**Landscape Review Committee
ZOOM Online Meeting
September 2, 2020 - 12:00 PM**

DATE: September 2, 2020
TO: Landscape Review Committee Members
FROM: Jamie Fleckenstein, Associate Planner
SUBJECT: Agenda Item 4A – Landscape Plan Review Application (L 21-20)

DECISION, CONDITIONS, FINDINGS OF FACT AND CONCLUSIONARY FINDINGS FOR THE APPROVAL OF A LANDSCAPE PLAN REVIEW FOR AN URGENT CARE CLINIC AT 1755 SW BAKER STREET

DOCKET: L 21-20 (Landscape Plan Review)

Figure 2: Zoning Map**Figure 3: Proposed Landscape Plan****Attachments:**

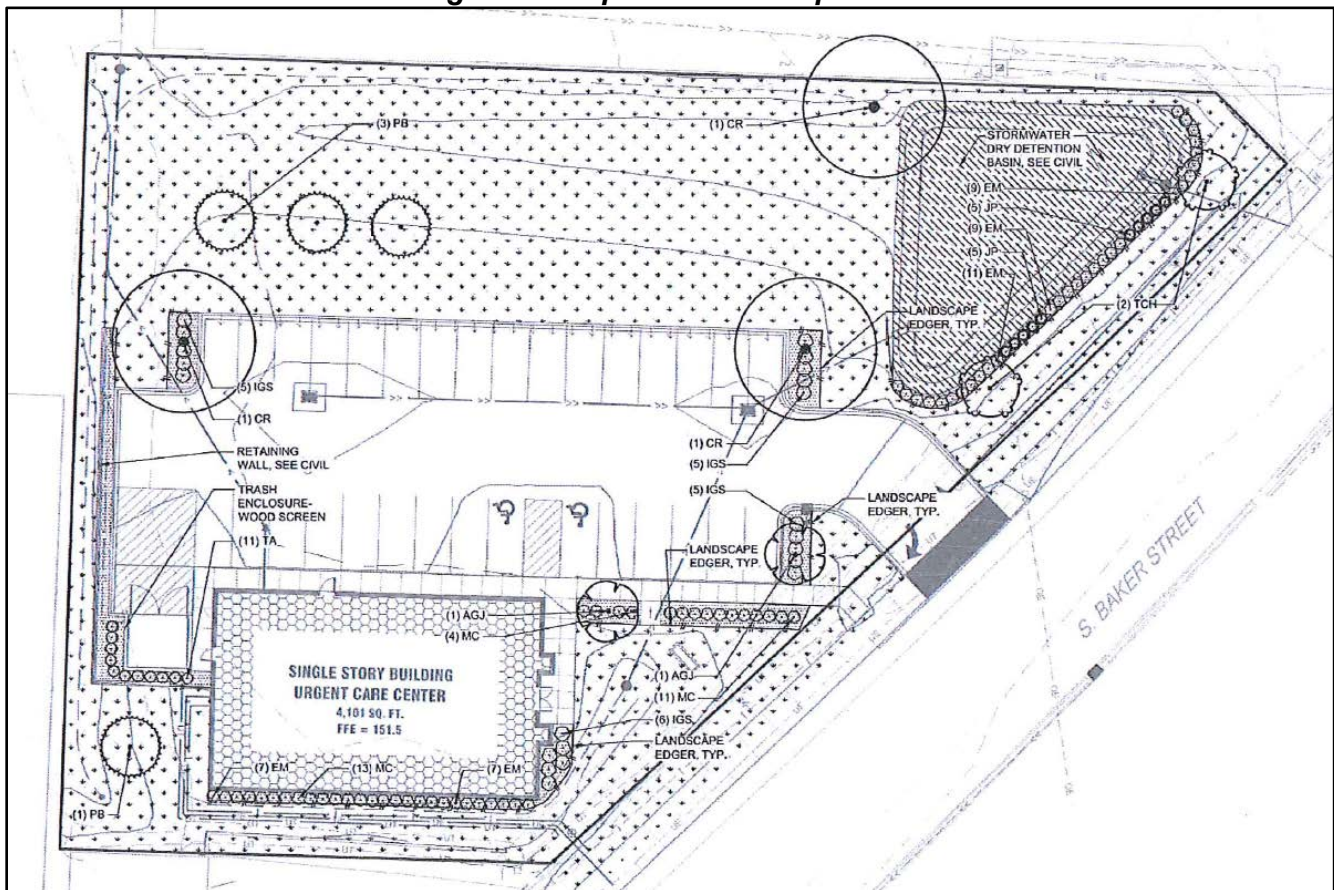
FINDING: SATISFIED. The proposed site plan for the urgent care clinic features a single vehicular access from Highway 99W leading to an off-street parking lot located in the middle of the property with 31 spaces. South of the parking lot is the proposed urgent care clinic which is an approximately 4,100 square foot, single-story building. North of the parking lot, a stormwater detention basis is located along the SW Baker Street frontage. No structures are proposed north of the parking lot. The landscape plan addresses landscaping for the entire property, including the perimeters of the urgent care clinic and parking lot, and the stormwater detention basin.

On the southern portion of the subject site, landscaping is provided around the perimeter of the proposed urgent care clinic and around the perimeter of the parking lot. On the south and east sides of the building, which are highly visible from the Baker Street right-of-way, foundation plantings include the evergreen shrubs *Ilex glabra* 'Shamrock' (Shamrock Inkberry) and the native *Mahonia aquifolium* 'Compacta' (Compact Oregon Grape) in combination with the ornamental grass *Elymus magellanicus* (Magellan Grass). Shamrock Inkberry grows to five (5) feet tall and wide, and Compact Oregon Grape grows to three (3) feet tall and wide. Magellan Grass is a lower growing grass known for its blue foliage and can be persistent in mild climates. The applicant has noted that planting on the south side of the building is limited to foundation shrubs because of the amount of utilities in the area.

Use of evergreen plantings continue around the southeastern corner of the parking lot, where additional Compact Oregon Grape and Shamrock Inkberry are proposed. Two (2) *Acer griseum* 'JFS KW8AGRI' (Fireburst Paperbark Maple) are also proposed adjacent to the southeast corner of the parking lot. The evergreen shrubs will provide screening and buffering of the parking lot. The Fireburst Paperbark Maples, deciduous trees that will reach approximately 25 feet tall and 18 feet wide will provide shade to the parking area. Fireburst Paperbark Maples are identified as appropriate for planting under wires on the McMinnville Street Tree List. Overhead power and communications run along the property frontage along the north side of Baker Street, and the selection of a small tree appropriate for under overhead wires will help reduce and avoid future conflict with the utilities.

A trash enclosure is located near the southwest corner of the parking area, and has an evergreen hedge of *Thuja occidentalis* 'Smaragd' (Emerald Arborvitae) on the south and west sides for screening. Additionally, an evergreen *Picea pungens glauca* (Colorado Blue Spruce) tree is proposed in the southwest corner of the property to provide additional screening and buffering of the adjacent properties and structures.

On the northern portion of the subject property, landscaping is proposed to help achieve several goals stated by the applicant. Landscaping around the parking lot will help provide screening and shade. A stormwater detention basin in the northeast corner of the property will provide stormwater collection and ecological functions, and planting along the frontage will help provide an aesthetic appearance appropriate for a property near a major gateway to McMinnville. The landscaping on the northern half of the site is oriented to accommodate future development in that space. The application indicates that the site is undergoing application for partitioning with the intention of additional future development.

Use of evergreen shrubs and deciduous trees continues in the northeast and northwest corners of the parking lot. In each planting area, Shamrock Inkberry is proposed, along with *Celtis reticulata* (Western Hackberry) tree, a native deciduous tree that grows to approximately 25 feet tall and wide. Just north of the parking lot are three (3) evergreen Colorado Blue Spruce trees to provide further screening from the adjacent properties to the north and west. East of the Spruce trees is the anticipated location of a future building, and landscaping has not been proposed in the area to accommodate that development.

Overall the characteristics of the proposed landscaping is compatible with the project and the adjacent surrounding properties. Planting is focused around highly visible locations and will help create an aesthetically pleasing appearance at a major gateway to McMinnville. The mix of evergreen shrubs and ornamental grasses will provide screening and buffering of uses on the site. Trees are appropriately sized and spaced to avoid conflicts with overhead wires and will help provide shade and screening to the parking lot. Planting within the stormwater detention basin is appropriate for the function, and provides an ecological aesthetic. Overall, staff finds the landscape plan is compatible with the proposed project and surrounding properties and uses.

FINDING: SATISFIED. The proposed use is screened from neighboring properties and uses by a combination of deciduous shade trees, evergreen trees, and evergreen shrubs. The shade trees around the perimeter of the parking lot site are small trees, selected to provide screening and interest, and to avoid conflict with overhead utility lines. Evergreen shrubs ranging in height from three (3) to five (5) feet tall will help screen and buffer the parking lot from right-of-way and

Figure 5: Irrigation Plan**Attachments:**

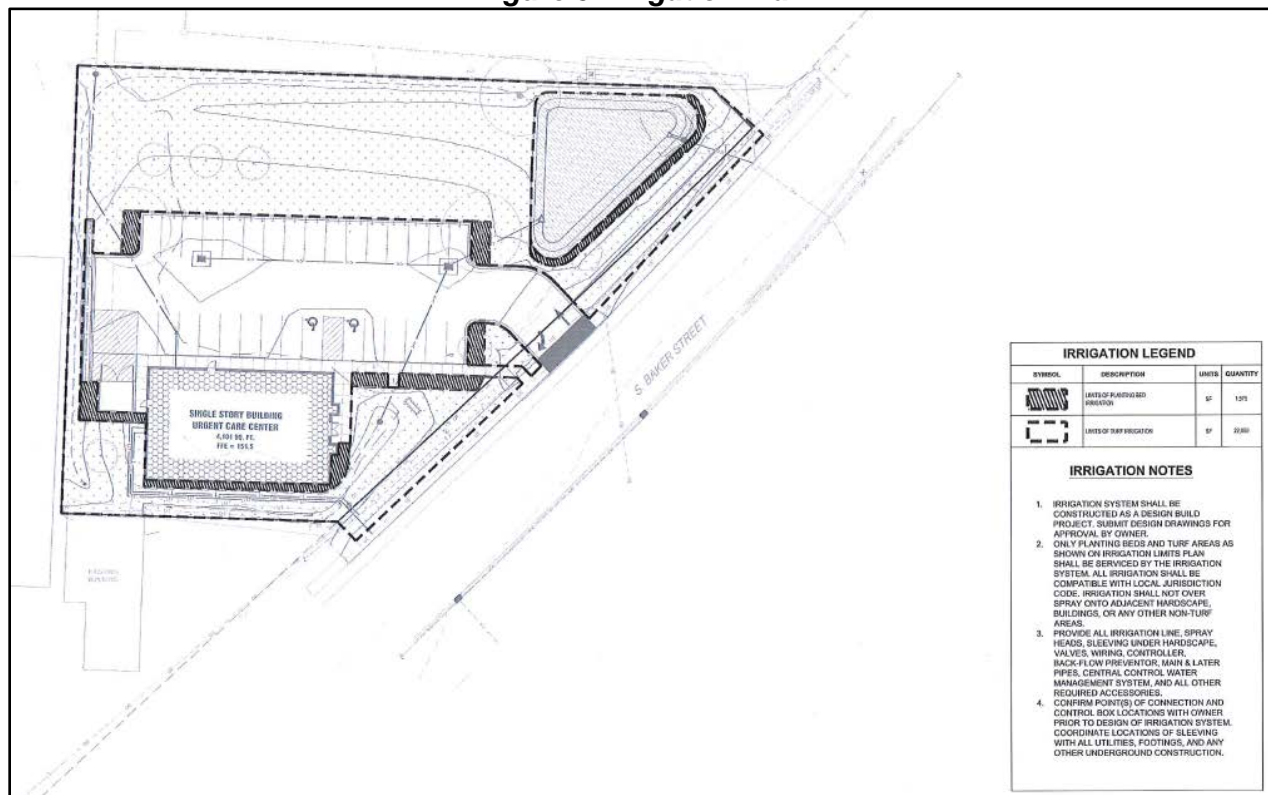
FINDING: SATISFIED. The landscape plan application includes an irrigation plan (see below), specifying a design/build automatic irrigation system. Planting beds and turf areas would be on separate zones, as indicated on the plan. The stormwater detention basin would not be irrigated.

SITE RESTORATION & PLANTING PLAN

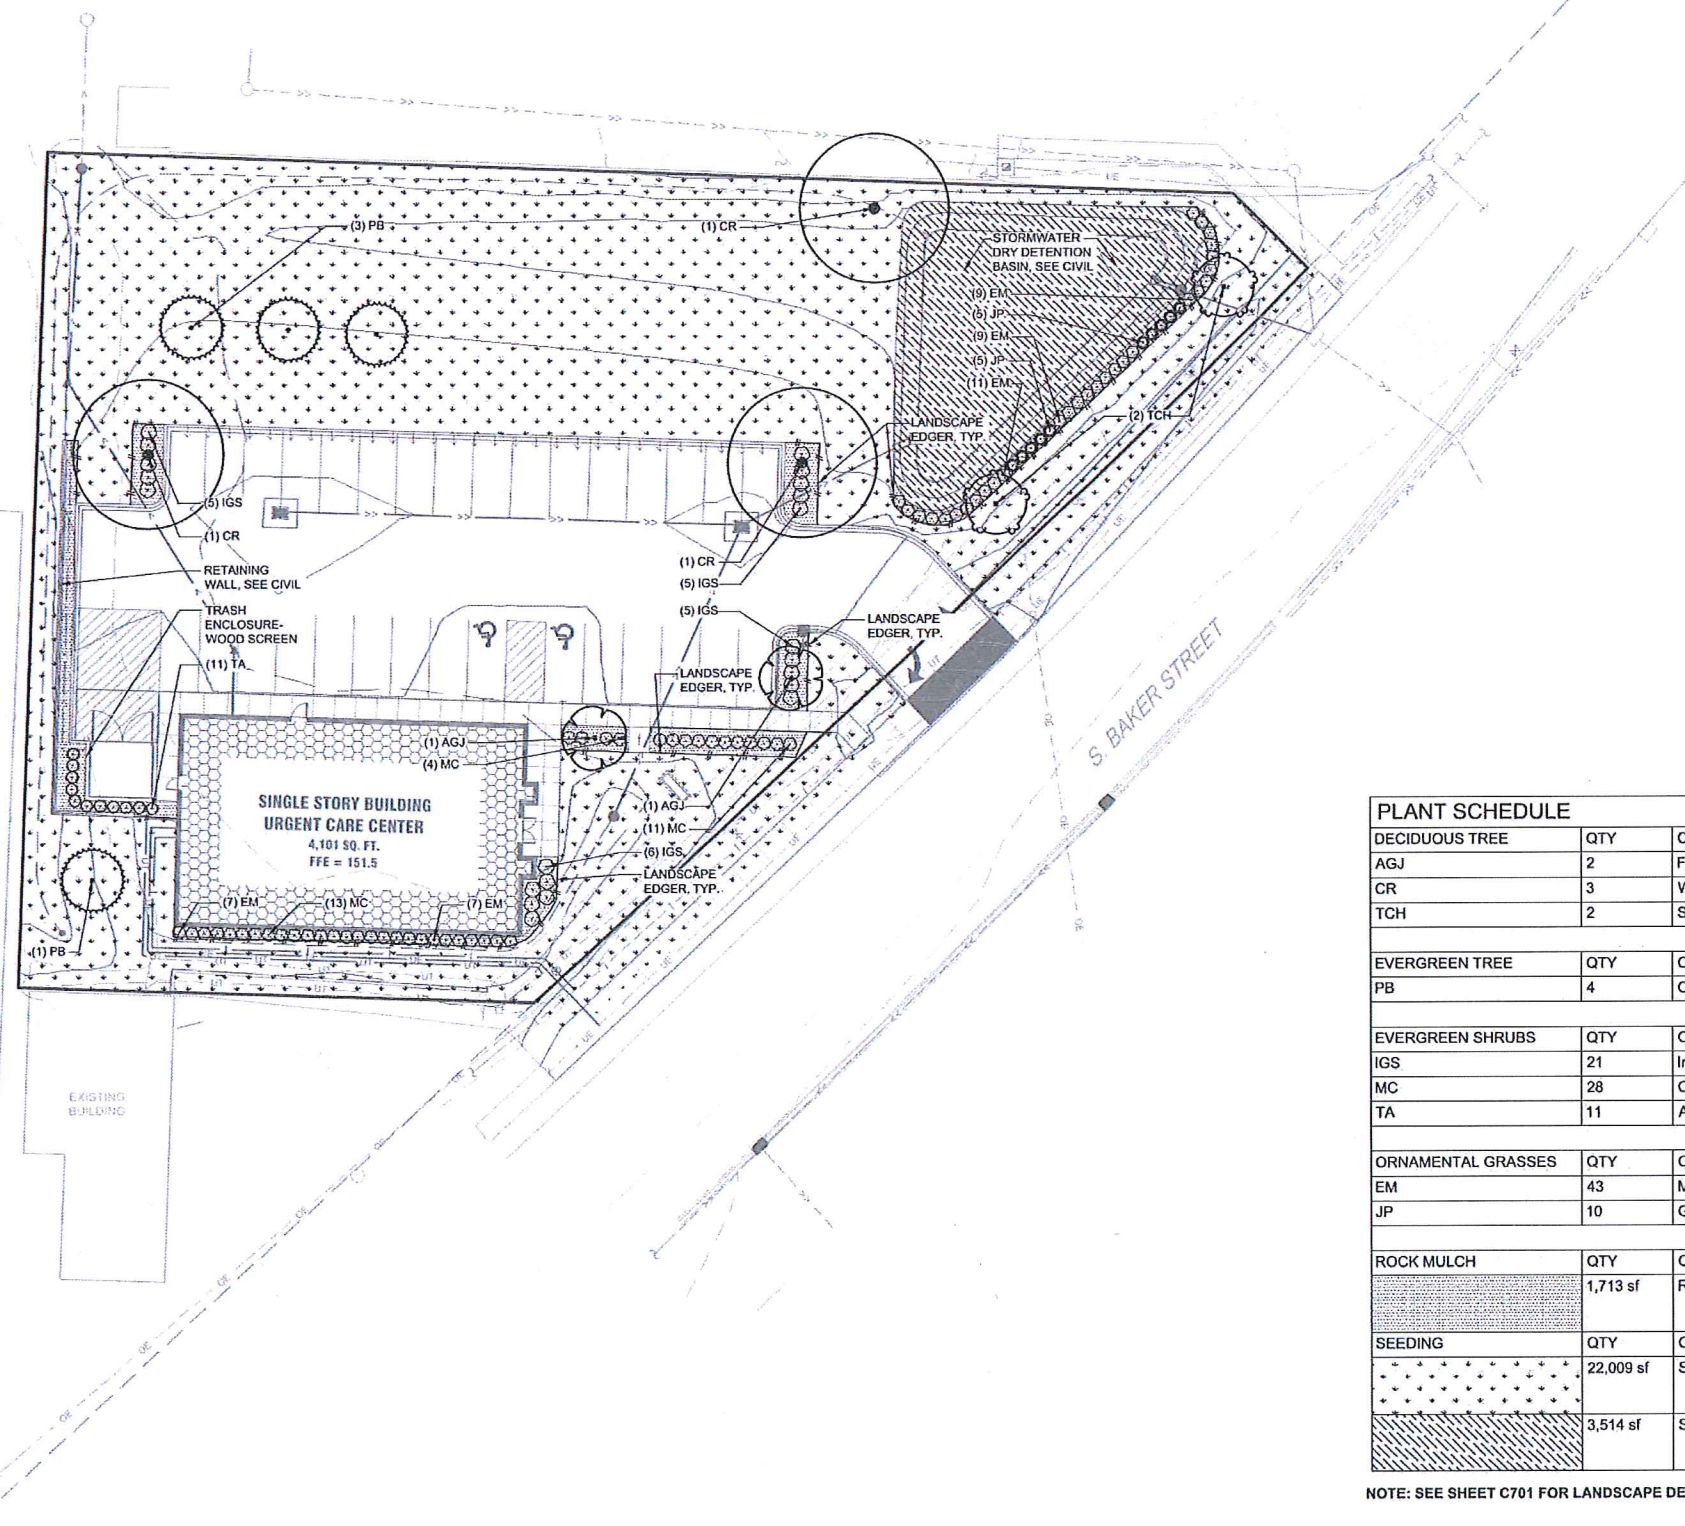
2. 17.57.070(B)(2) requires screening of the proposed use, typically through the location of trees, screening plantings, or other screens around the perimeter of the site or other key locations on the property. It does not appear that screening of uses (clinic building, off-street parking) is addressed in a meaningful way.

3. 17.57.070(B)(4) requires planting and islands to break up parking lots. A stated purpose and intent of the Landscaping Chapter is to provide "parking lot landscaping to reduce the harmful effects of heat, noise and glare associated with motor vehicle use" (MMC 17.57.010(A)(4)). No planting islands or perimeter planting around the parking area is provided that would help accomplish the purpose of the code.

ISG Response: Additional landscaping has been added to help screen the property and improve the aesthetic consistent with adjacent properties.

ISG Response: Additional trees and shrubs have been added and the landscape islands are located on the four corners of the parking lot. The site is undergoing a lot split for a future use to the north and to maximize parking for a new use additional landscape islands were not proposed beyond the four islands currently proposed
